Authors response to editor's comments

Manuscript number: bg-2018-477

Title: Kinetics of calcite precipitation by ureolytic bacteria under aerobic and anaerobic conditions

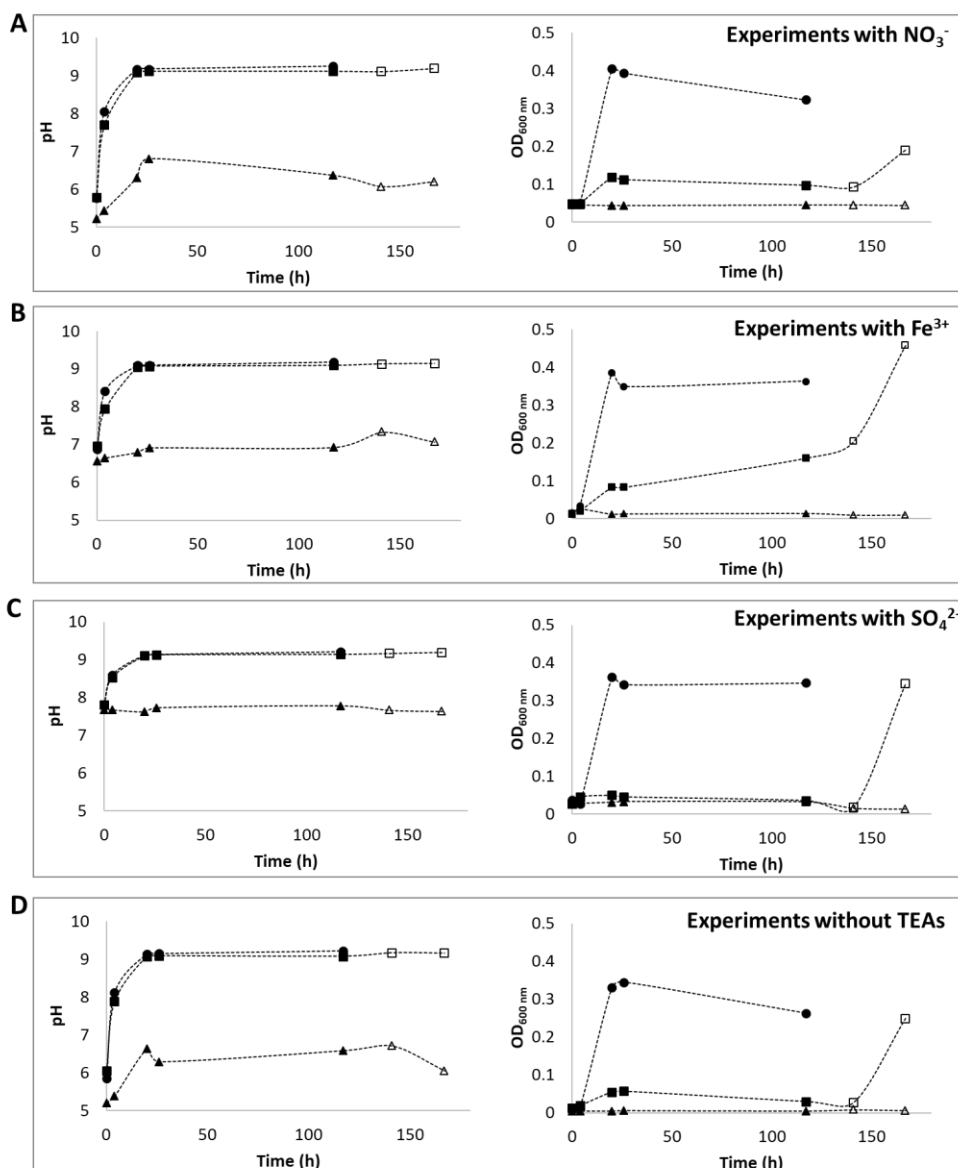
Comment 8: Figure 4: Give abbreviation TEAs in the figure caption. There are only open data points for some panels, why? Why have OD measurements and not pH after the bottles were opened?

Response: *We included the abbreviation TEAs in the figure caption in the revised version of the manuscript. We have also modified Figure 4 and included the open data points for the pH graphs. The corrected figure has been included in the modified version of the manuscript and for reference below.*
